N491NAS1

TECHNICAL BULLETIN

Non-Compliance Recall: Incorrect Tire Placard and Tire Pressure Label

MODEL:	MODEL YEAR:	VIN:
Range Rover Sport (LW)	2020	700009-748957
Range Rover Sport (LW)	2020	876368-899994
Range Rover Sport (LW)	2021	749276-751417

E270294

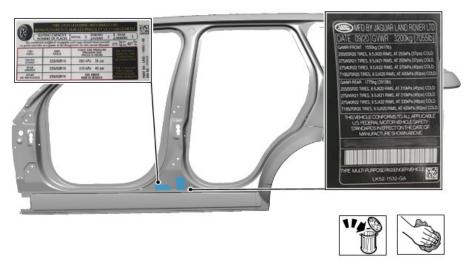
Remove and discard the tire placard and tire pressure label.

The new tire placard and tire pressure label must be installed in the same positions as the previous tire placard and tire pressure label.

- Clean the surrounding area.
- Remove the backing from the new tire placard and tire pressure label.
- Install the new tire placard and tire pressure label.
- 3. Close both left doors.
